ADDENDUM NO. 04

TO SPECIFICATIONS AND CONTRACT DOCUMENTS FOR INVITATION TO BID BIMT NEW ENTRANCE & ROADWAY JPA CONTRACT NO.: C-1951

ADDENDUM NO. 04

INVITATION TO BID BIMT NEW ENTRANCE & ROADWAY

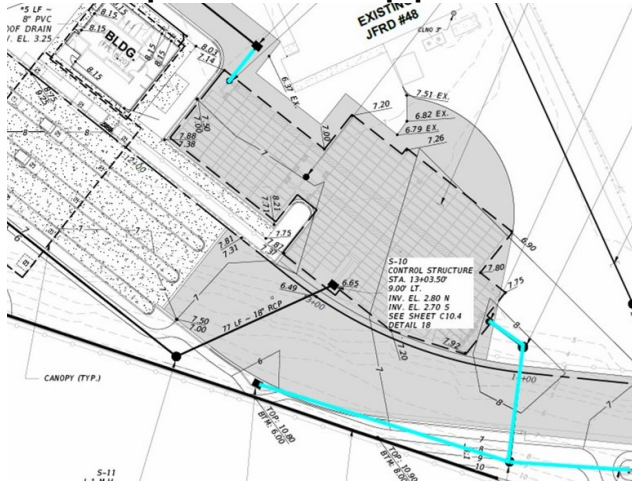
4. E-200 Lighting Plan Keynotes (5)
Please provide mentioned timeswitch detail in Note 5.

ANSWER: Refer to included Exterior Lighting Control Detail.
